Macquarie River to Orange pipeline project

Preferred project report

February 2013

Figure 3.1 Observed and climate corrected demand for Orange

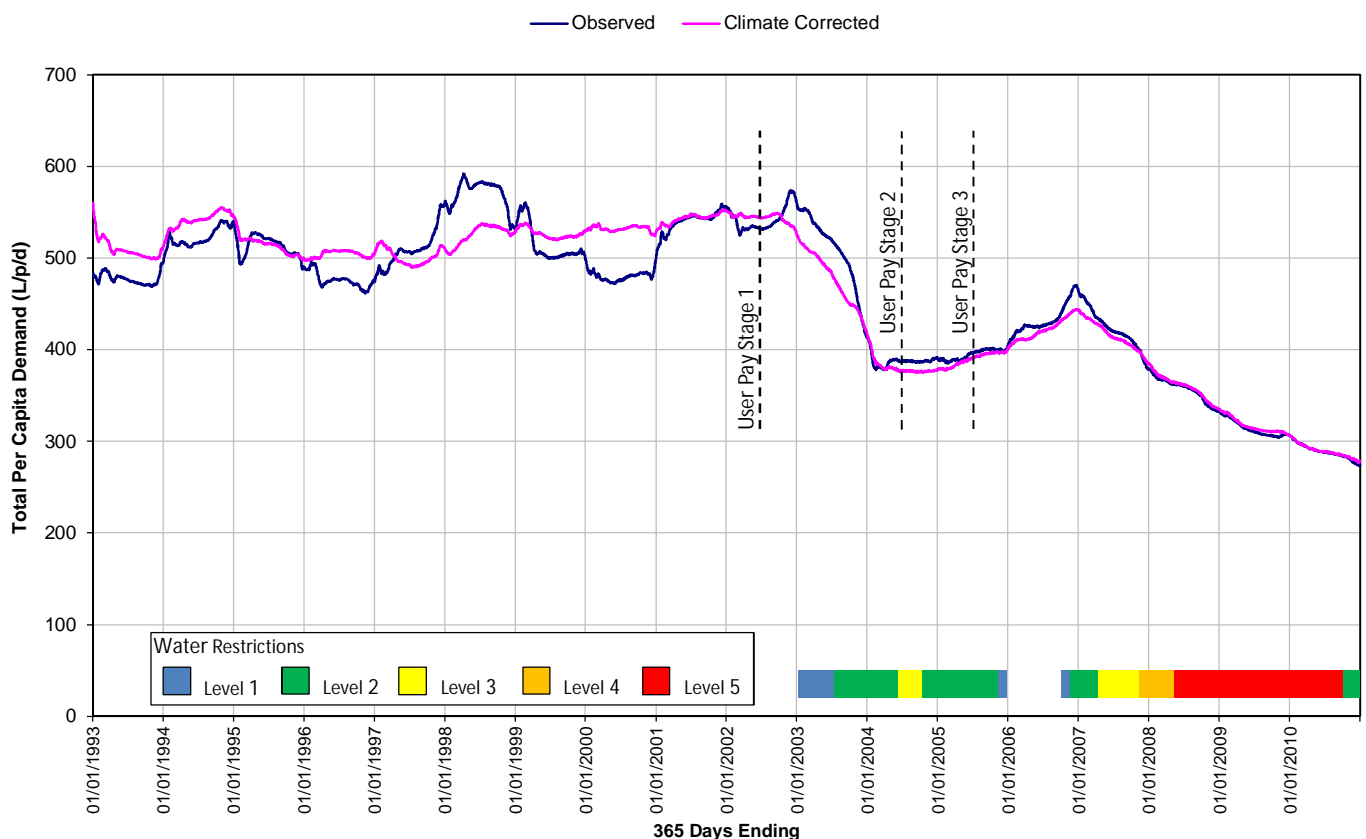
- ▶ Please clarify the assumptions for unrestricted water demand. It would help if this could be considered against the pre-BASIX water demand for Orange. Submissions also raised comparisons of water demand with Canberra and Goulburn, and this should also be considered.
- ▶ Further explanation about how a scenario based on the last 10 years is appropriate given that these were dry years.

A description of how the baseline level of demand (404 L/p/day) was derived is provided above. Historical data indicates that level of demand is not much higher than recent years (refer Figure 3.1). The data presented in Table 3.1 shows that the residential component of this demand is typically lower than most other comparable regional centres.

Figure 4.1 Location of Marebone Weir in relation to the Macquarie Marshes

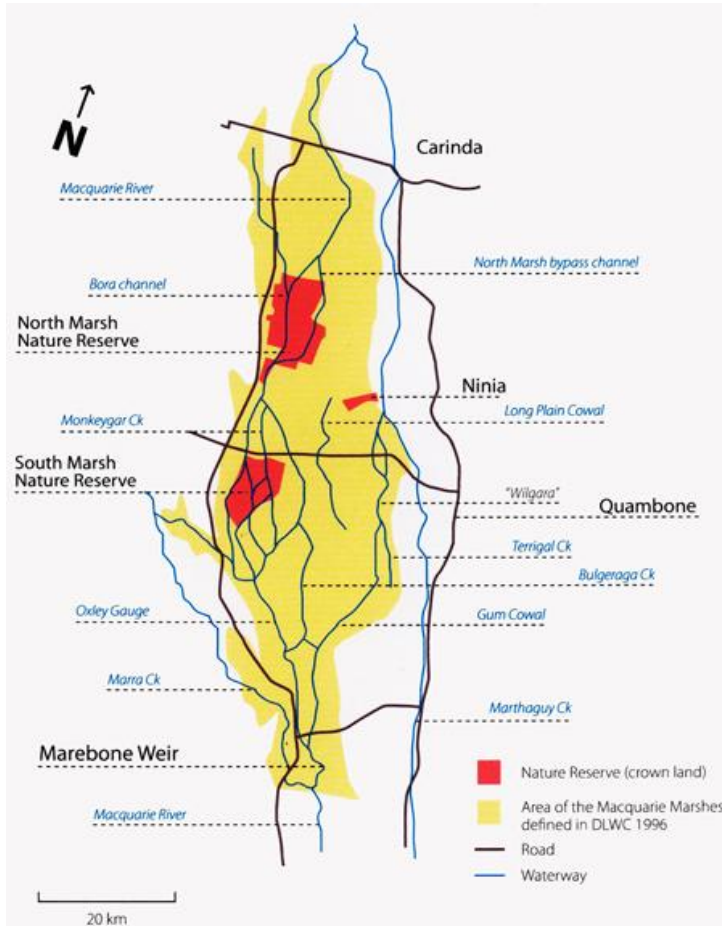
p. 10.12 – The location of Marebone Weir is not clearly shown. Can a figure be provided showing this?

Refer to Figure 4.1.
